Access Compliance Report

Public Rights-of-Way

Intersection ID: 44723	Main Street: PROSPERITY_CHURCH_RD	Cross Street: JOHNSTON_OEHLER_RD	Location: SE
ADA ID: 5D14C43BEC9A	Ramp Type: Perp	Initial Pass/Fail: Fail	Overall Compliance: No
Severity Score: 21.25			
Codes/Mitigation Info/Possible Solution		Field Measurements/Component Compliance

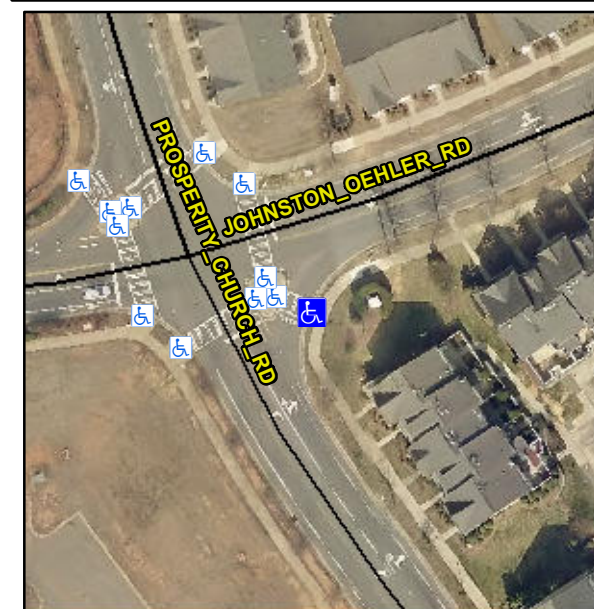
R304.5.1, R304.2.2

Compliance	Description	Data	Compliance	Description	Data
N/A	Ramp Length (in)	60.0	No	Ramp Slope (%)	8.8
No	Ramp Width (in)	46.0	Yes	Ramp XSlope (%)	0.5
N/A	Flare Type LT	N/A	N/A	Flare Type RT	N/A
N/A	Flare Slope LT (%)	N/A	N/A	Flare Slope RT (%)	N/A
N/A	Flare Traversable LT?	N/A	N/A	Flare Traversable RT?	N/A
N/A	Landing Length (in)	N/A	N/A	DWS Provided?	N/A
N/A	Landing Width (in)	N/A	N/A	DWS Contrast?	N/A
N/A	Landing Slope (%)	N/A	N/A	DWS Length (in)	N/A
N/A	Landing X Slope (%)	N/A	N/A	DWS Full Width?	N/A
N/A	Landing Curb? (Y/N)	N/A	N/A	DWS Offset (in)	N/A
N/A	Shared Landing?	N/A			
N/A	Gutter Ponding?	N/A	N/A	Gutter Slope (%)	N/A
N/A	Gutter Lip Ht (in)	N/A	N/A	Gutter X Slope (%)	N/A
N/A	Painted X Walk1?	Yes	N/A	Painted X Walk2?	N/A
	X Walk 1 Direction	To NW		X Walk 2 Direction	N/A
N/A	X Walk 1 Width (in)	112.0	N/A	X Walk 2 Width (in)	N/A
	X Walk 1 Slope (%)	2.8		X Walk 2 Slope (%)	N/A
	X Walk 1 X Slope (%)	0.5		X Walk 2 X Slope (%)	N/A

Remove & Replace Entire Ramp.
